Modification Report Section 4.55(1A) Modification

**Orica Southlands Warehouse Estate
SSD 9691 Mod 1**

Prepared for Goodman Property Services (Aust.) Pty Ltd
Submitted to the Department of Planning, Industry and
Environment

December 2021

Figure 3: Site piles plan (Source: Costin Roe)

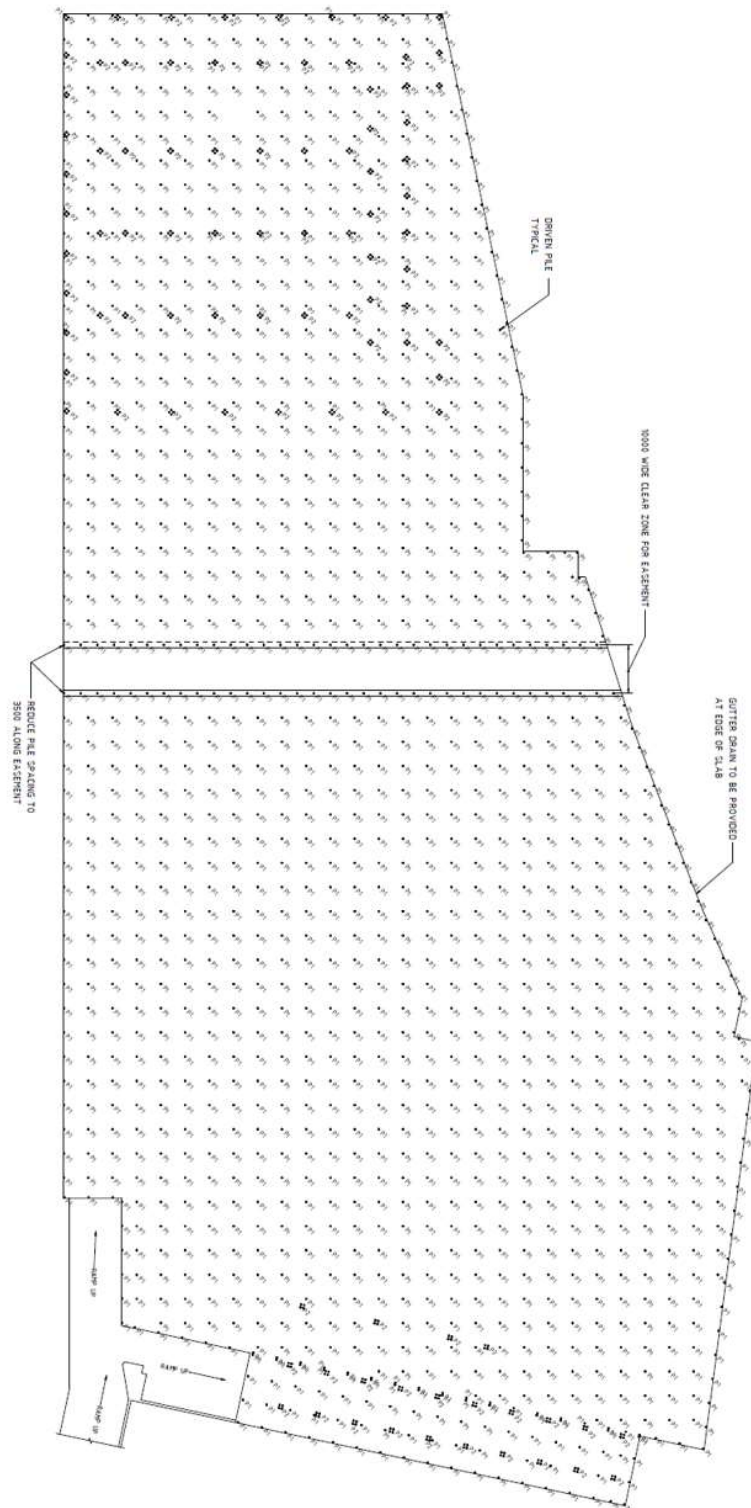
- changing the intervals of the supporting piles from 10m to generally 5m with additional piles to support structures on top of the elevated platform
- reducing the size of each individual piles from 800mm to 400mm in diameter
- no longer including footings for the piles

The revised pile design is shown within Figure 3 and the plans at Appendix 3.

The elevated concrete platform remains and is now supported on a grid of smaller diameter piles spaced at a closer grid. While the number of supports is increased, the diameter is reduced and the volume loss from these structures is approximately 235 m³, compared with approximately 200 m³ under the approved design. The associated loss of storage volume of approximately 35 m³ remains less than approximately 0.14% of the total storage capacity of the basin which is approximately 28,500 m³.

The spacing of the piles is designed to ensure that access for maintenance vehicles under the platform is maintained. A 10 m corridor is provided along the easement (Figure 3) and the 5 m spacings across the remainder of the basin can accommodate the maintenance vehicles as currently required and contemplated within the existing approval.

JOB NO.	DRAWING NO.	REV	DATE	TITLE
9349.13	SK-15	B	17/12/2021	Driven Pile Only Plan

Figure 4: Change in peak flood levels in the PMF event in a blocked scenario (Source: BMT)

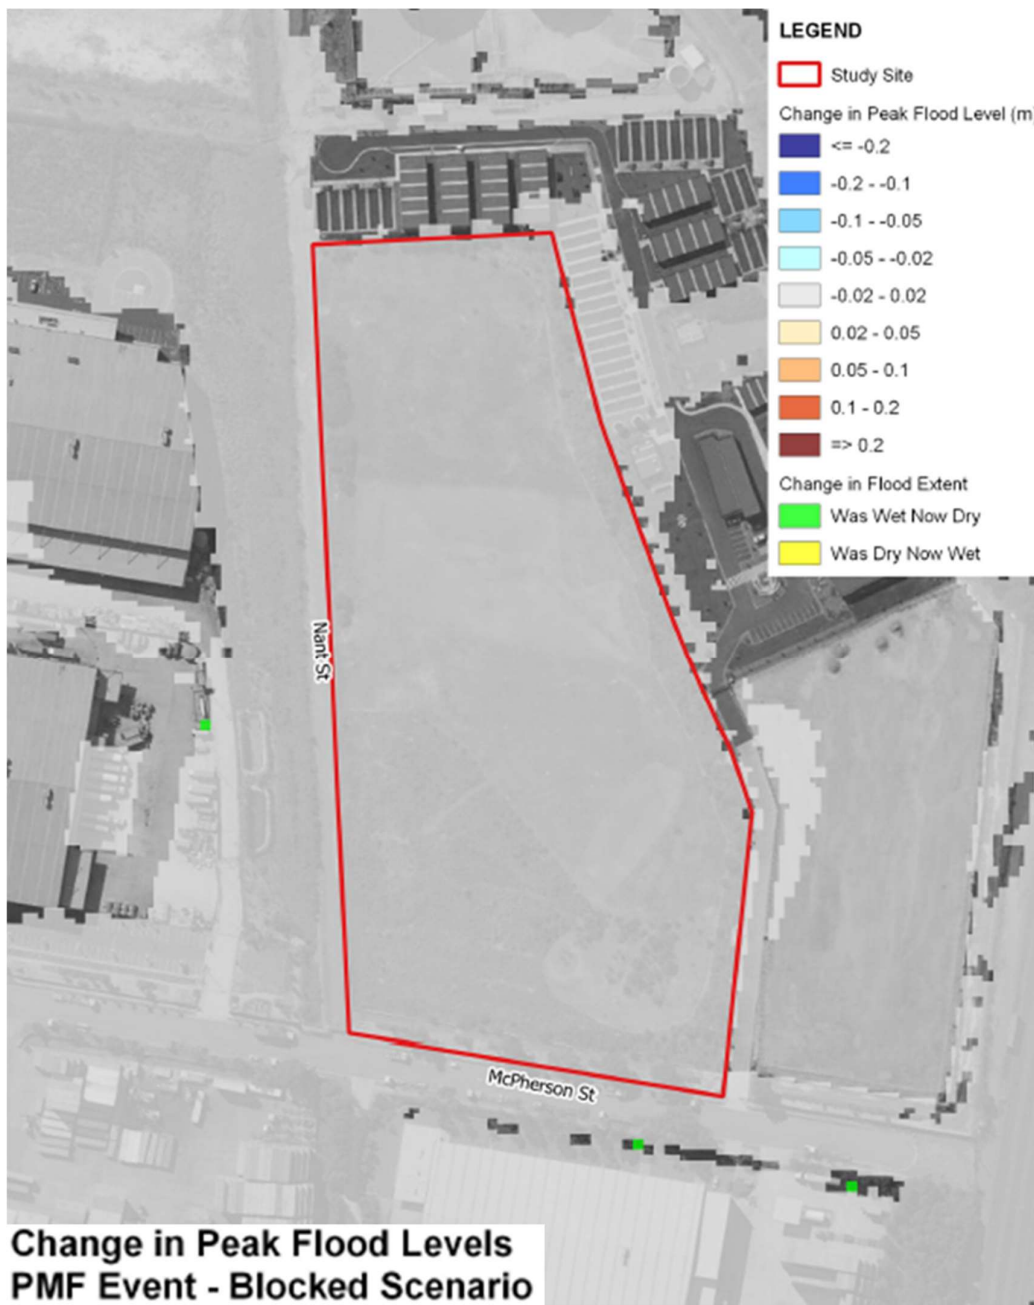
Overall, the modelling and maps provided within the FIA demonstrate that the revised pile design will result in negligible off-site impacts for all flood events and drainage scenarios modelled. The results are also consistent with those reported in the FIA submitted with SSD 9691 despite the changes proposed to the pile configuration design. The change in peak flood levels during the PMF event and a blocked drainage scenario is demonstrated at Figure 4.

Figure 5: Change in peak flood hazard in the PMF event in a blocked scenario (Source: BMT)

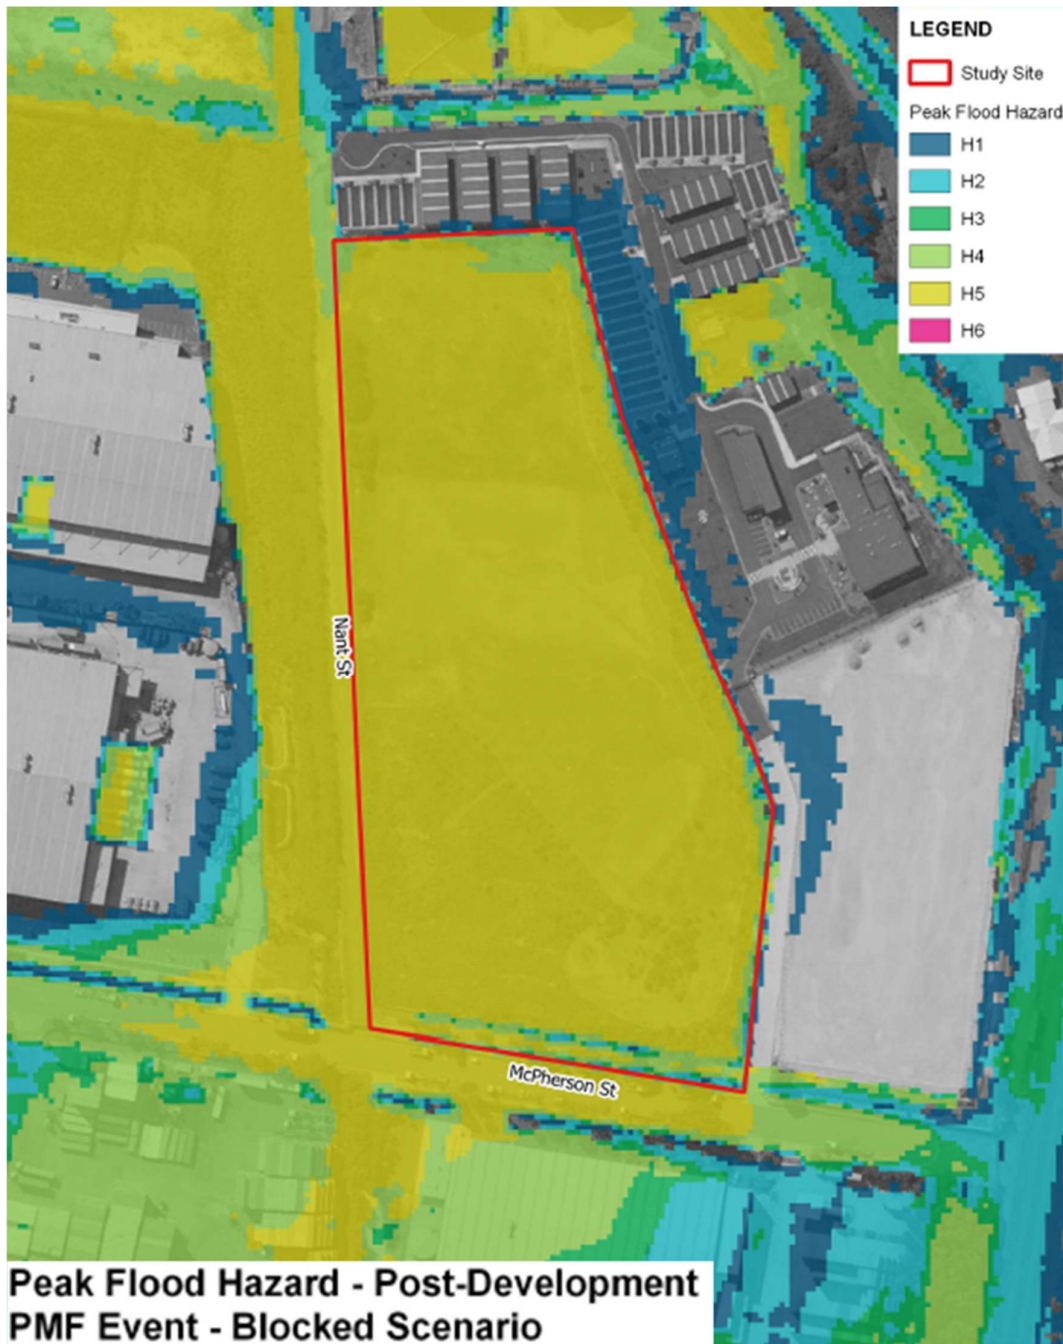
The FIA also considered predicted flood hazard levels on site. The flood hazard maps provided within the FIA demonstrate the highest flood hazard in the undercroft area can reach category “H5” on the flood hazard curve during the PMF event. Flood hazard mapping for the PMF event in a blocked drainage scenario is provided at Figure 5. Buildings and structures within the H5 zone could be vulnerable to structural damage.

Accordingly, all structures within the undercroft area are to be designed and constructed to withstand forces under the PMF event. Detailed design will ensure the piles are reinforced to provide the required structural resistance to the calculated impact forces.
